PROJECT TITLE: Dewsbury and District Hospital ADDRESS: Holton Rd, Dewsbury, Wt3 4JG

DRAWING TITLE: General Arrangements

DRAWING REFERENCE					
PROJECT	ORGANISER	VOLUME	DATE	ROLE	NUMBER
180598	DGL	01	ZZ	DR	A 2000

SUITABILITY	SCALE	SHEET	REV
CR	As Constructed	As Indicated	A0 CR2

00_Ground_Floor_Plan 1:100

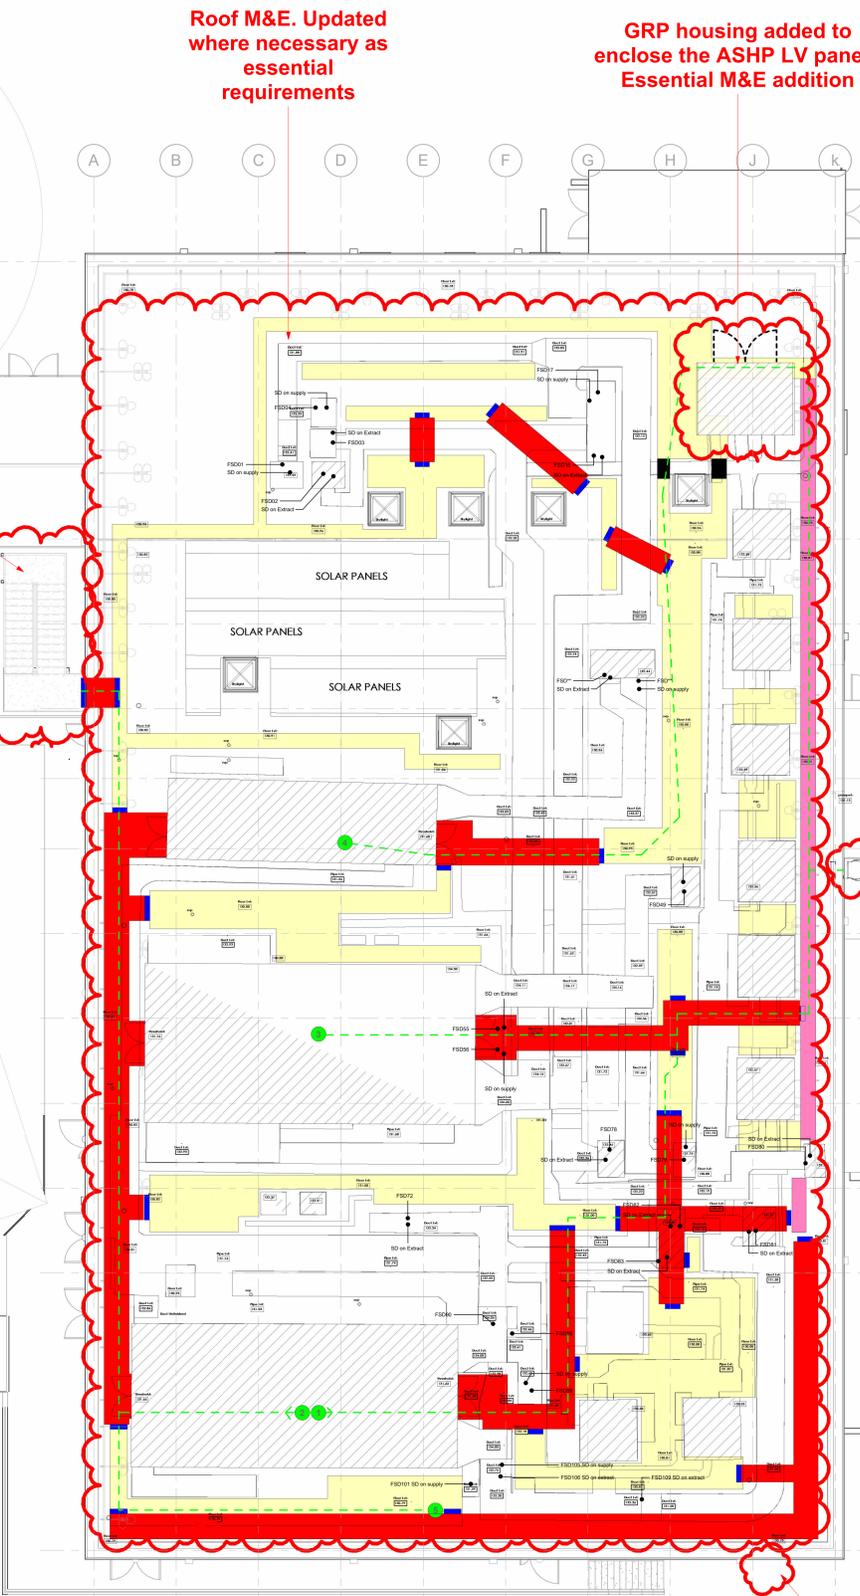
New external staircase - required for maintenance and as a more appropriate means of primary escape

Walkway wall and railing omitted - no longer required

External door omitted - no longer needed

LV rooms added - Essential M&E addition with protective external walls for safety

New external staircase - required for maintenance and as a more appropriate means of primary escape

CAT ladder relocated. More appropriate location

Fence added to house condenser and enclose CAT ladder

IPS / UPS single storey addition. Essential M&E addition with protective external walls for safety

Mini plinth wall - to deal with unforeseen foundations / levels and ground issues

Previous location of CAT ladder - no longer appropriate as a secondary means of escape

Roof M&E. Updated where necessary as essential requirements

GRP housing added to enclose the ASHP LV panel - Essential M&E addition

CAT ladder relocated. More appropriate location

Previous location of CAT ladder - no longer appropriate as a secondary means of escape
